APSU fail action

Leon Bruckman, Nvidia

APSU FAIL state

Figure 178B-10—Training control state diagram

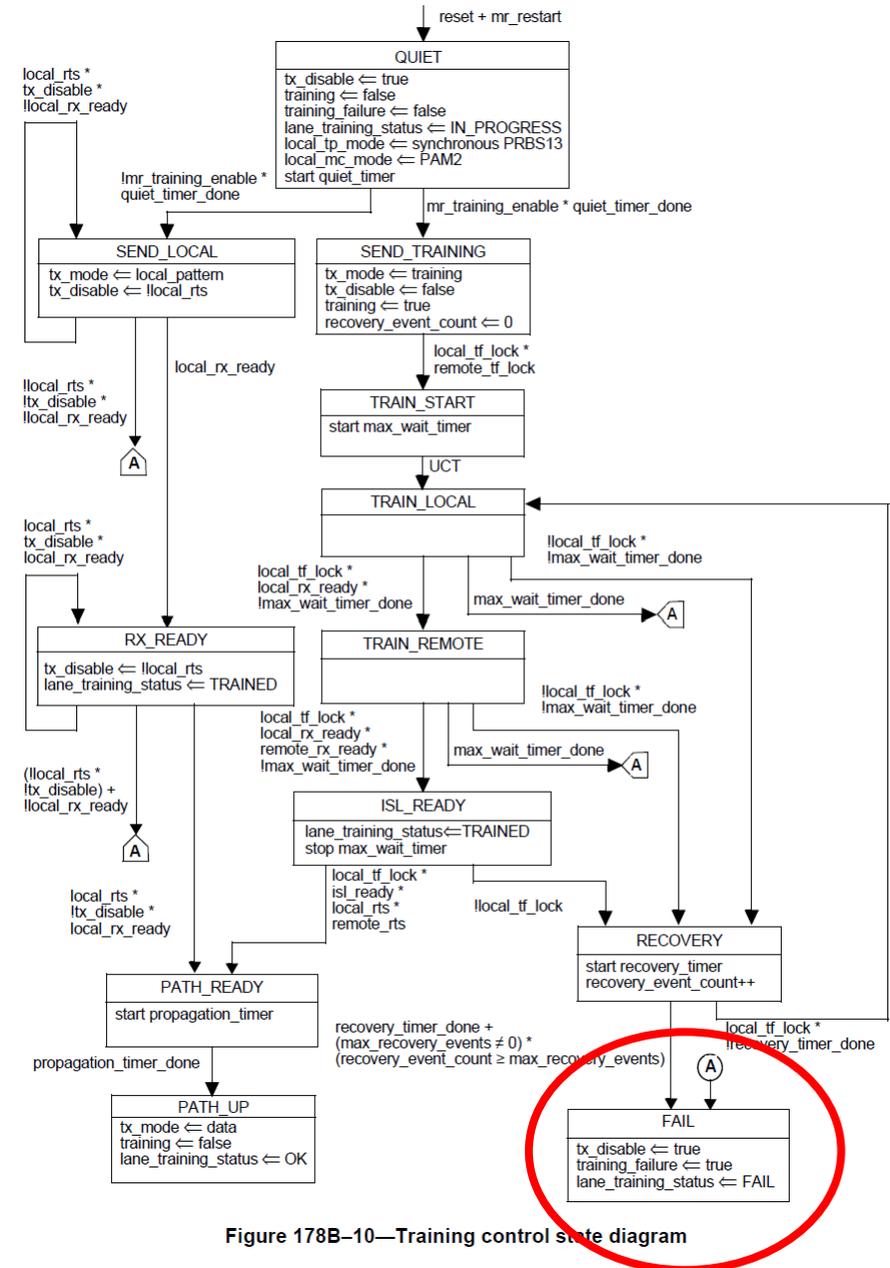
- In the “Training control state diagram” there is no indication how to exit the FAIL state.
 - The expectation is that the management takes care of the situation
- Lack of explicit specifications may lead to interoperability issues

- Add text to the note, or add a new note:
 - Recovery from FAIL state requires management to assert `mr_restart_training` or `reset`. The timing for this recovery is implementation dependent.

Expected behavior

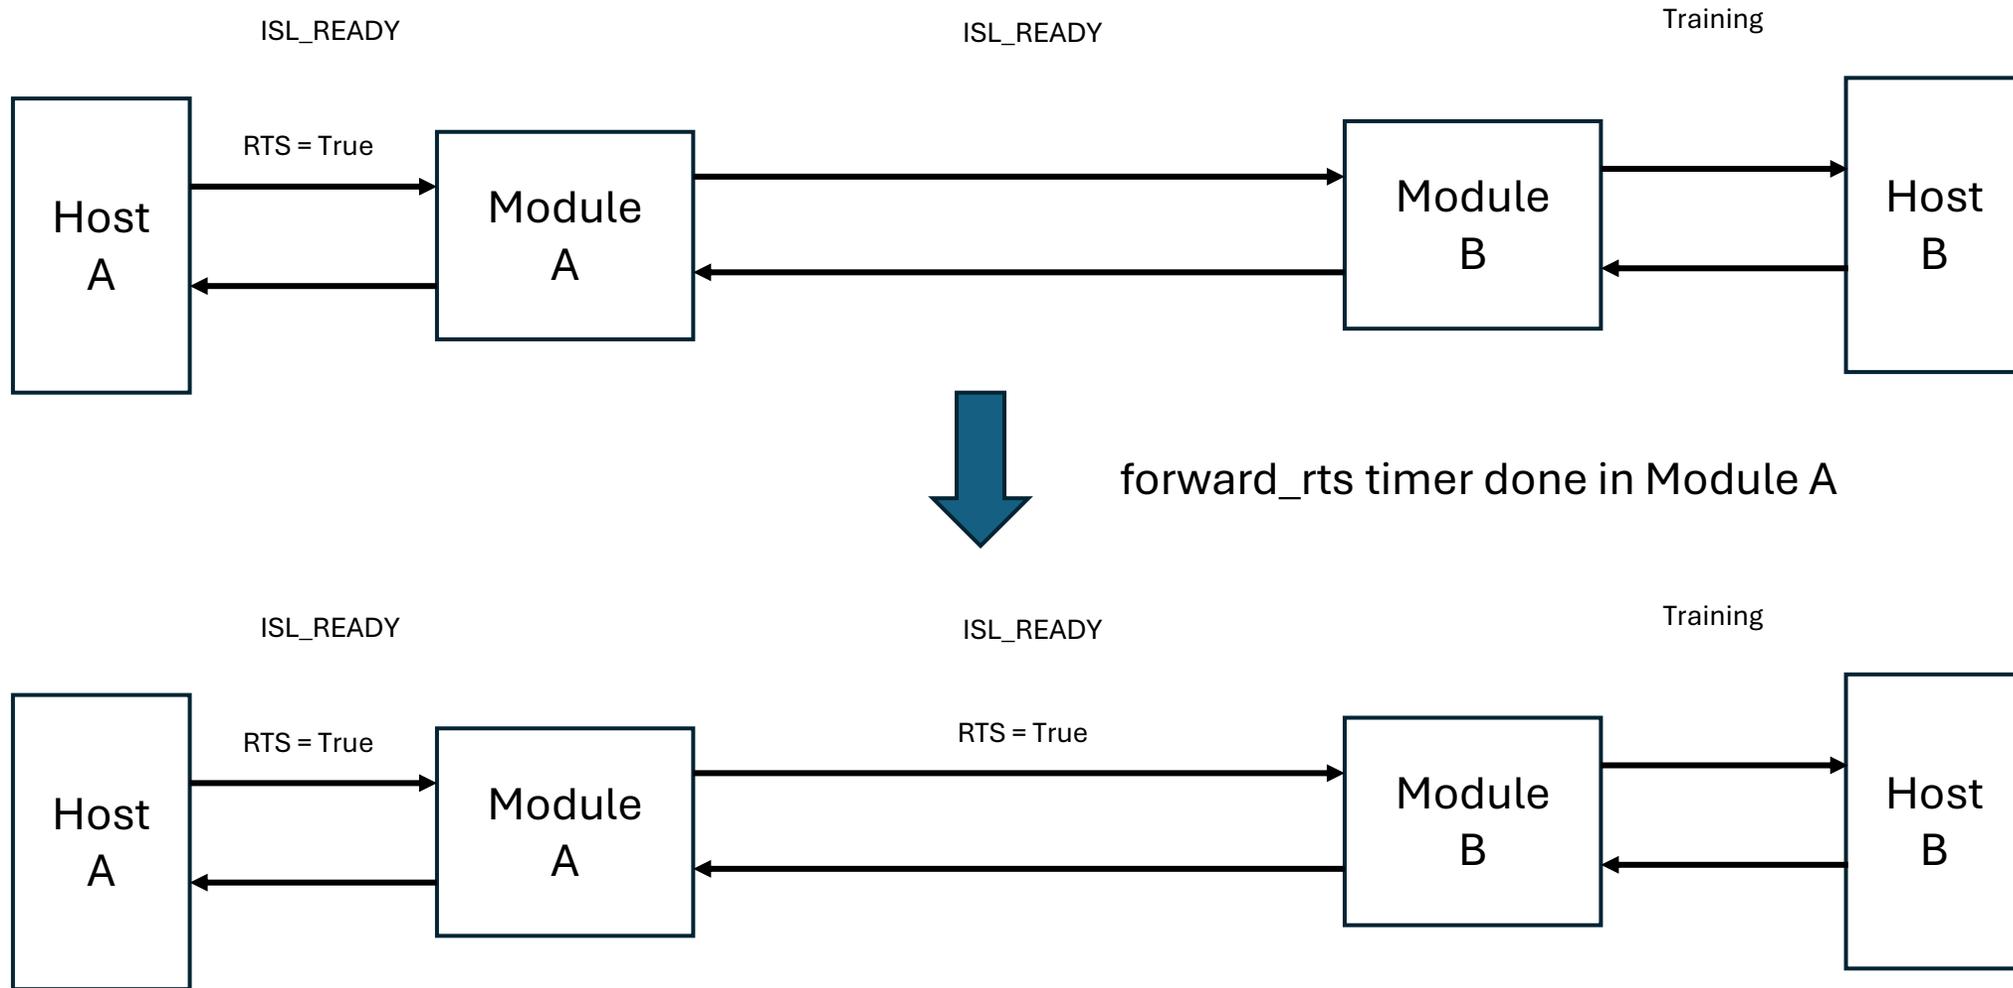
- If interface A of an ISL loses TF lock (`local_tf_lock = false`) and reaches the FAIL state in will set `tx_disable = true`
- Interface B (the peer interface in the ISL) will be either in the TRAIN_LOCAL, TRAIN_REMOTE or ISL_READY states waiting for responses from side A

- Interface B will lose TF lock (loss of signal) and also reach the FAIL state
- Management will need to decide if and when to restart APSU
- This is addressed by a note in D3.0:

- It is not clear if reaching the FAIL state is an unrecoverable fault
- The live-lock situation may occur if an ISL in the path is already in the PATH_READY state

- This live-lock situation is resolved by the APSU restart proposal
 - See separate contribution

Live-lock situation - 3

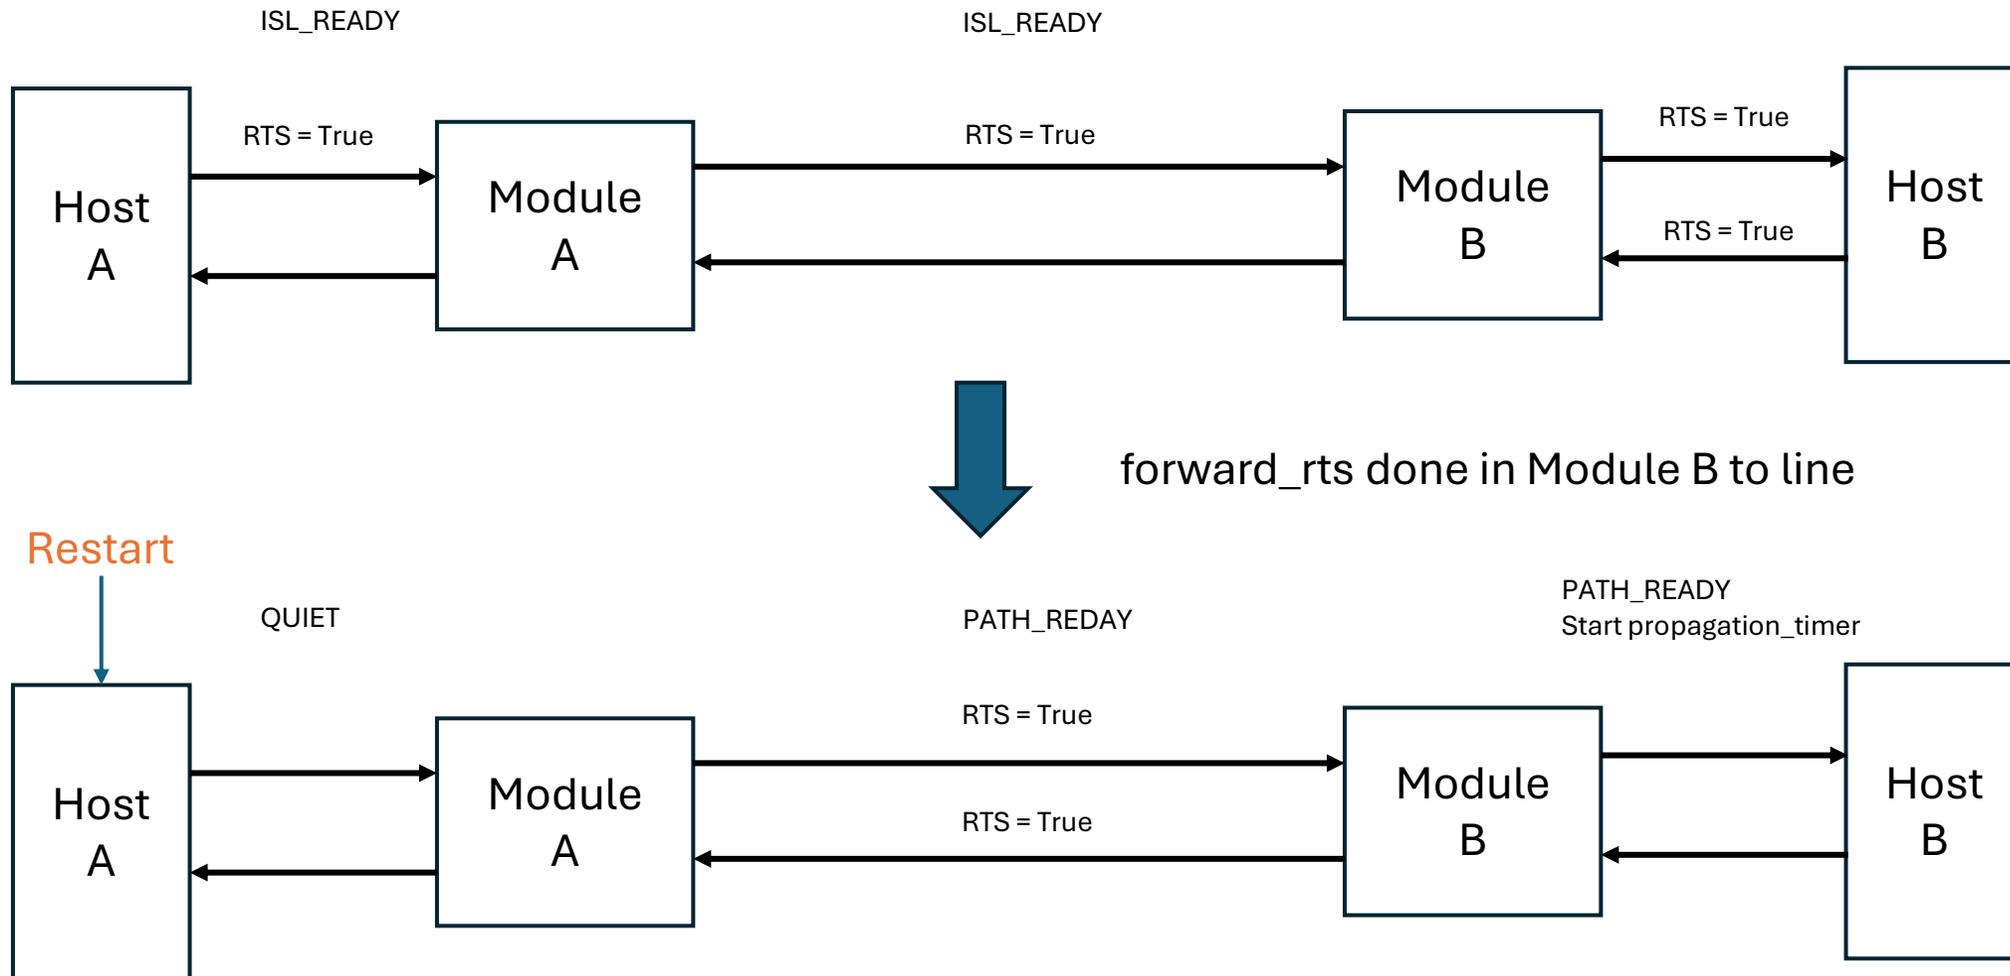
- Host B will move to `PATH_UP` after `propagation_timer` expires
- Host A will wait for `ILT` frames to move from `QUIET` state to `SEND_TRAINING` state
